ENGINEERING PRACTICE STUDY

TITLE: Proposed Changes to MIL-PRF-38535 Concerning Requirements for Internal Gas Analysis (IGA) Test Flow, and Addition of a Process Monitor Program

EP Study Project Number: 5962-2024-009

Final Report

Draft Proposed flowchart to add clarification to MIL-PRF-38535 Table V Group D (package related test) Subgroup 6, footnote 12/

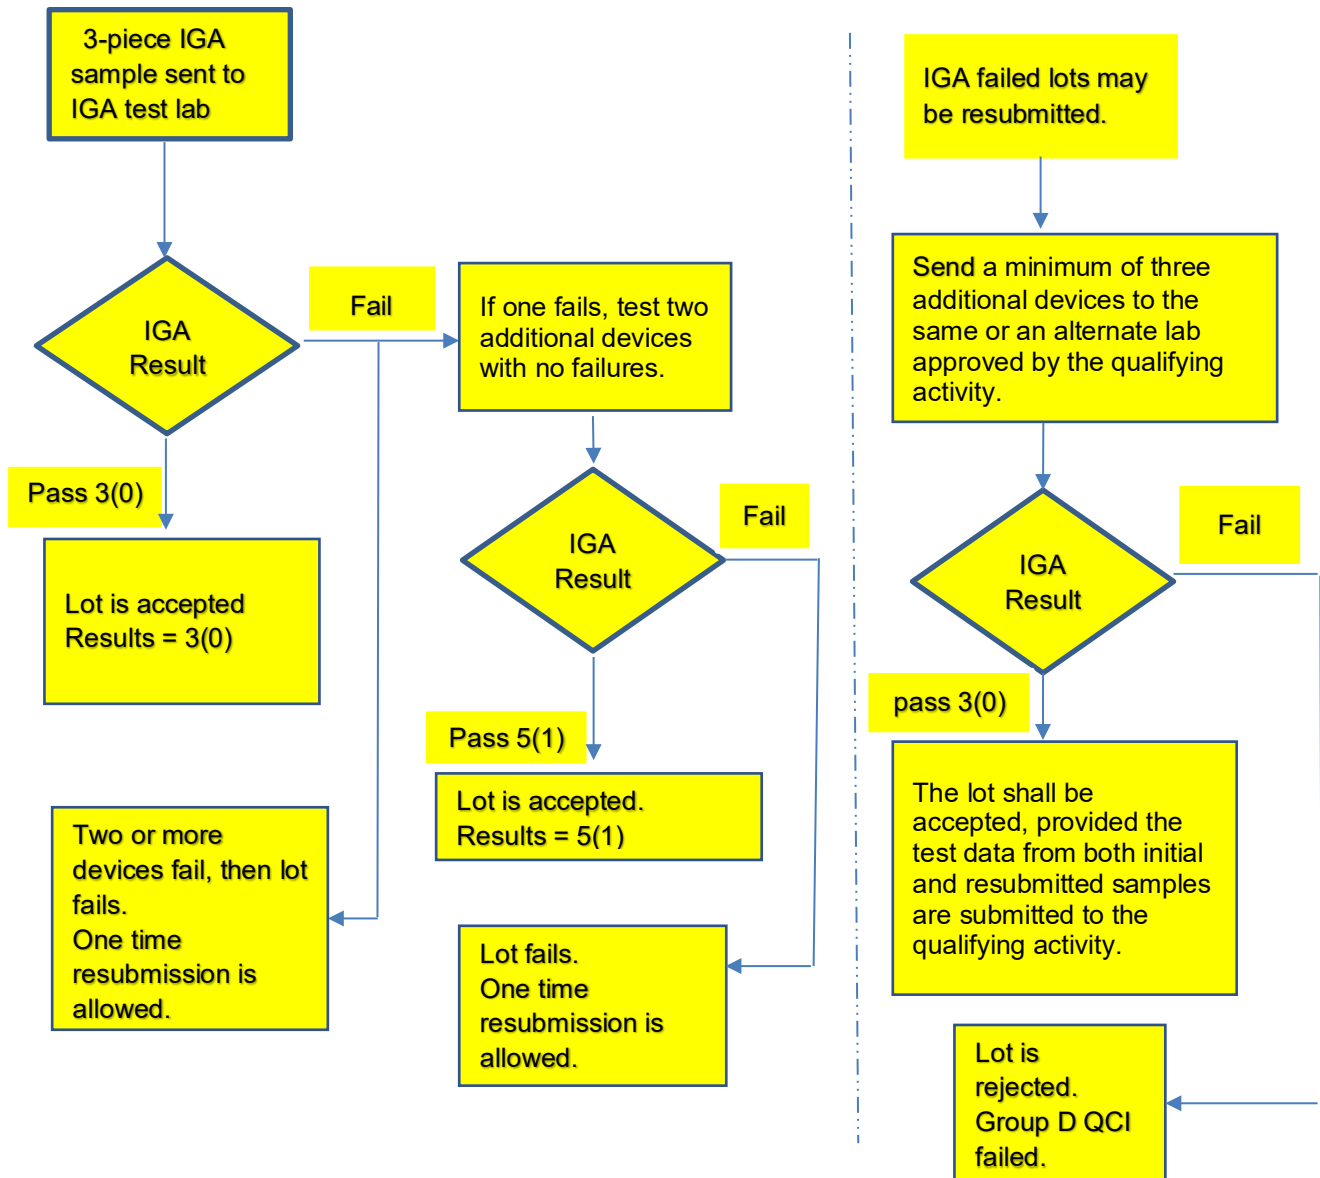
1. What are your overall thoughts and concerns regarding the proposed clarification in attachment #2 (Footnote 12/ and flow chart)?

- *8 agree with the proposed verbiage for greater clarification of footnote 12/.*
- *6 agree with the proposed footnote, however, disagree to last sentence: "The manufacturer shall evaluate any failure to determine the cause and potential risk to the lot".*

- *3 users recommend deleting footnote 12/.*
- *1 user express concerns about greater confidence needed to pass IGA test.*

- *Eliminate infrequent 3(0)/5(1) sampling. Adopt AQL sampling plans for each seal lot.*

3. Is a minimum of three additional devices a sufficient sample for "resubmission of failed lots for IGA test"? See attachment #2 flow chart.

- *13 device manufacturers agree that resubmitting of second complete sample three devices minimum is sufficient.*
- *1 device manufacturer also recommends 2nd resubmission should use a tighter samplings scheme.*

- *3 users responded no, citing that three devices are insufficient for resubmission and recommend resubmission should be doubling the original sample size (i.e., 6 samples, zero failures).*
- *1 user responded that current and proposed IGA test sampling and pass/fail criteria would be limited by several aspect such as test technology capability, precision, and accuracy.*
